No. 3 OF 3 SHEETS		
CITY OF HARTFORD, CONNECTICUT DEPARTMENT OF ENGINEERING		
BOILER FEED PUMP AND CONDENSATE RECEIVER		
HEAT RECLAIM DIAGRAM		
JOHN J. MCCOOK MEMORIAL HOSPITAL 2 HOLCOMB STREET		
DESIGNED BY <i>Daniel J. Farrell</i>	DRAWN BY <i>B. J. J.</i>	CHECKED BY <i>W. J. J.</i>
DATE OCT. 26, 1951	DAYBOOK NO. 09171-C

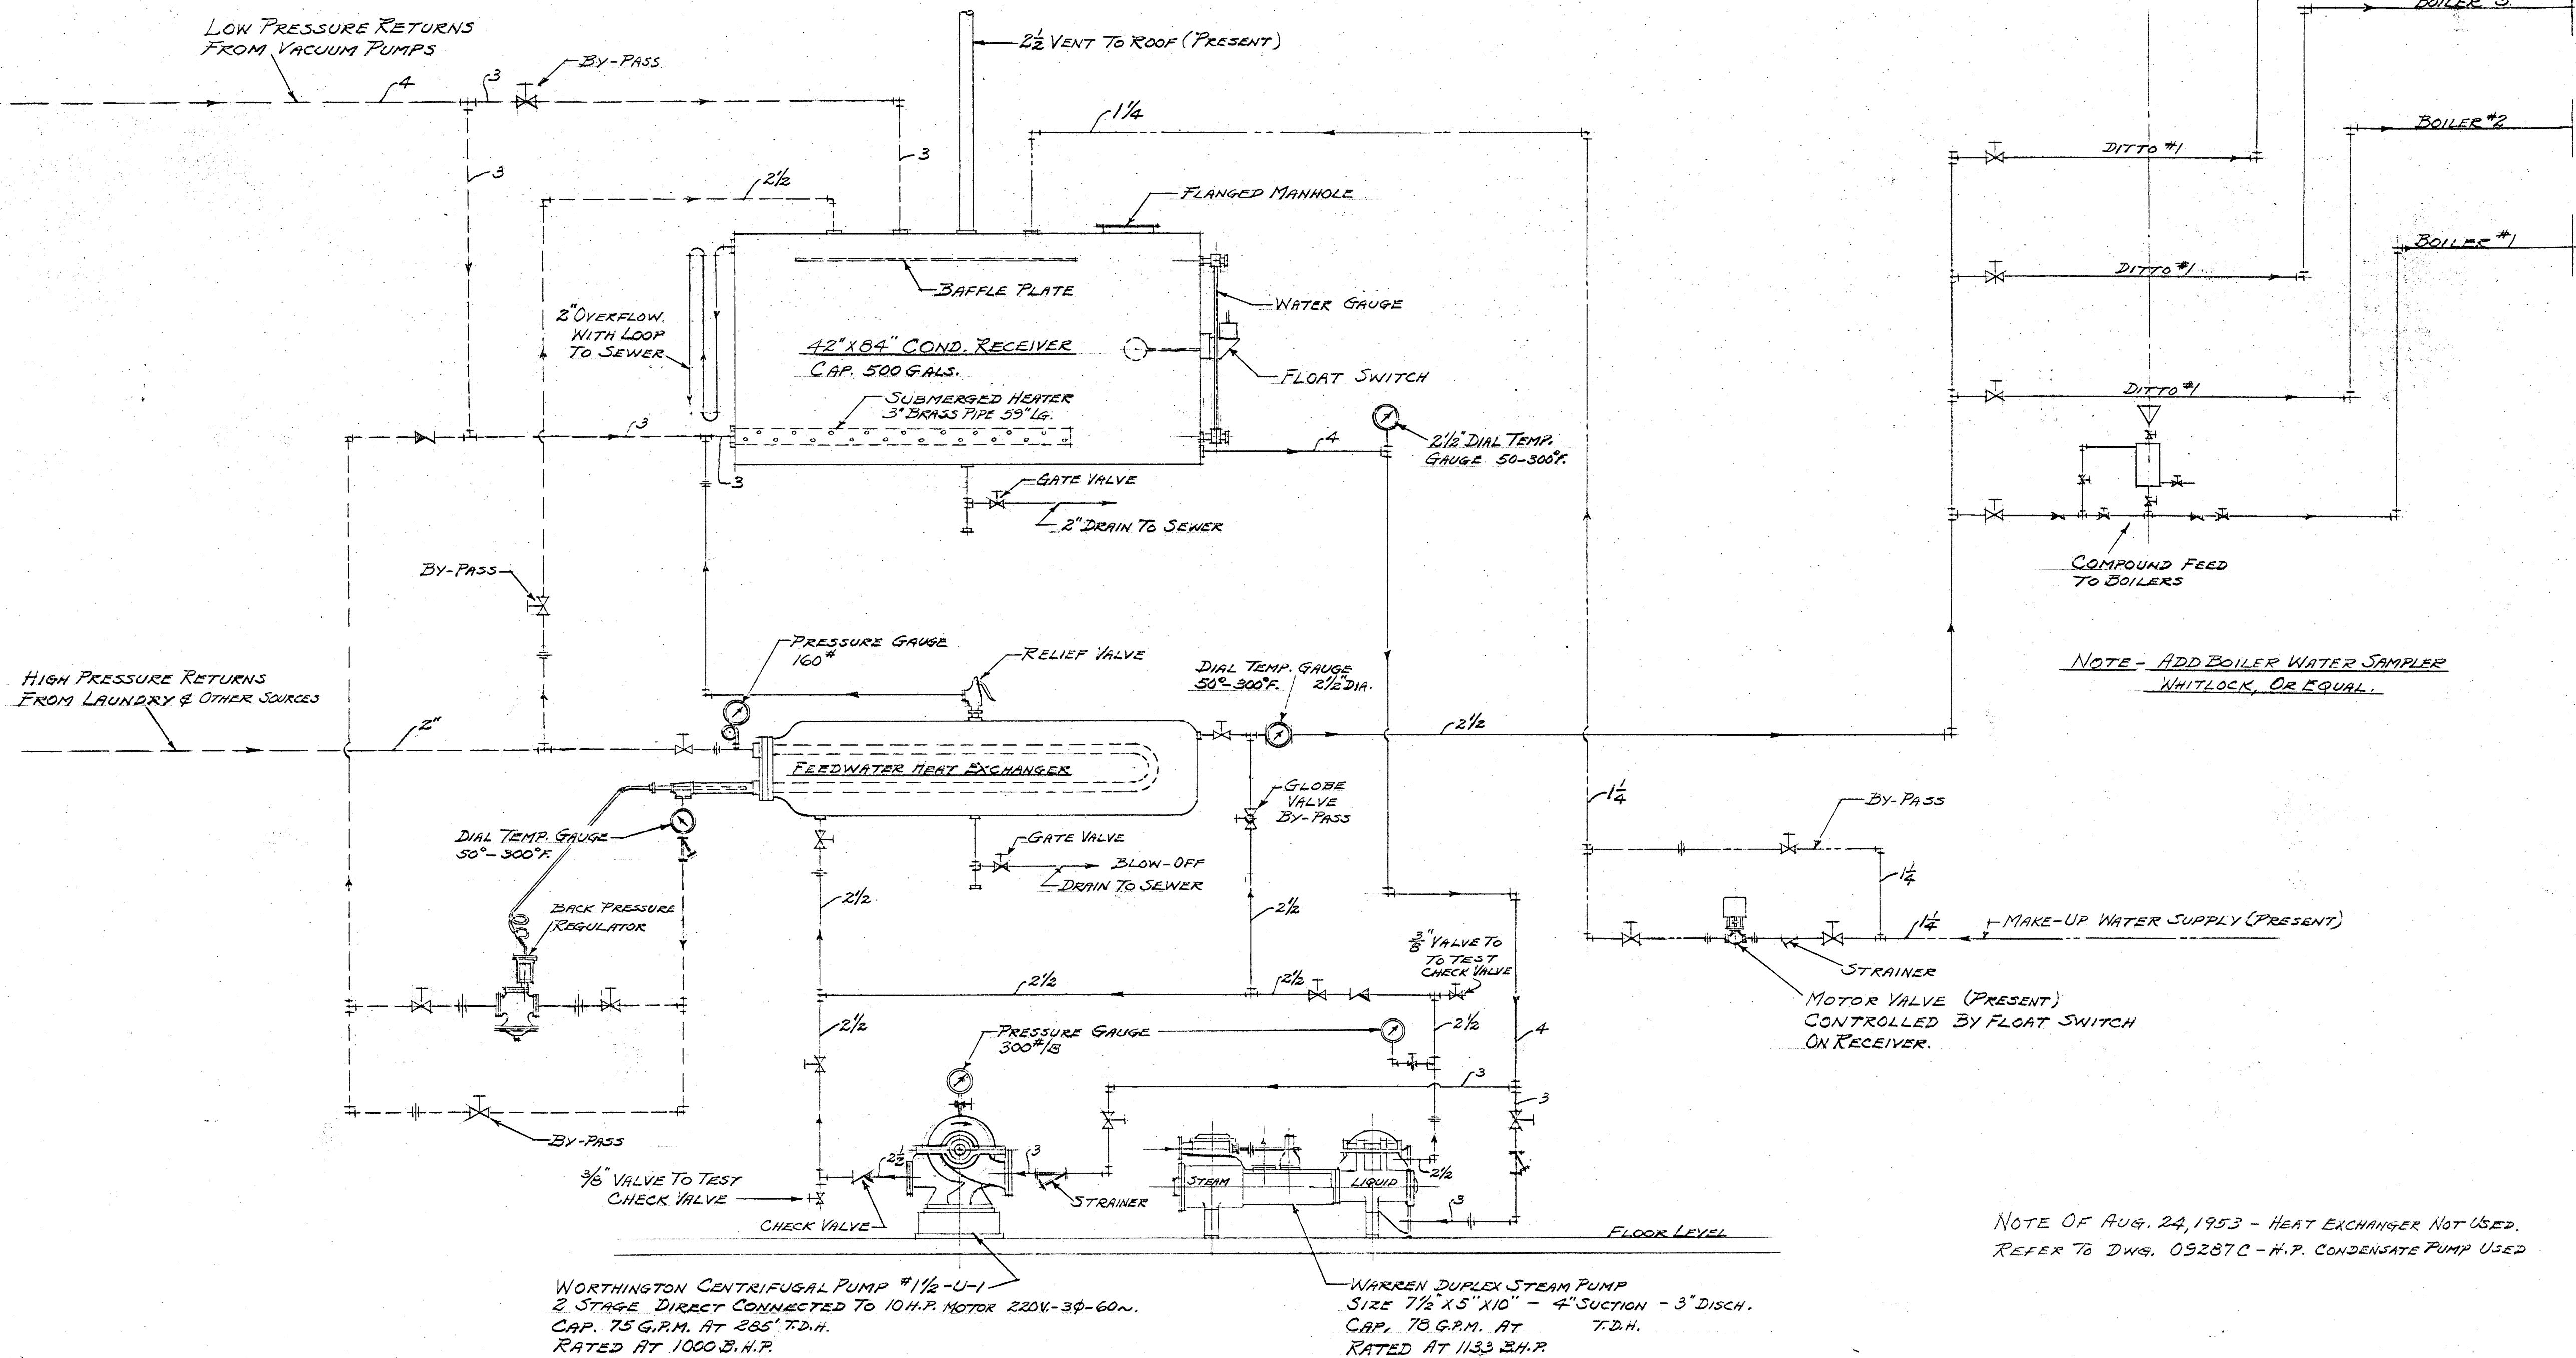
NOTE OF AUG. 24, 1953 - HEAT EXCHANGER NOT USED.
REFER TO DWG. 09287C - H.P. CONDENSATE PUMP USED
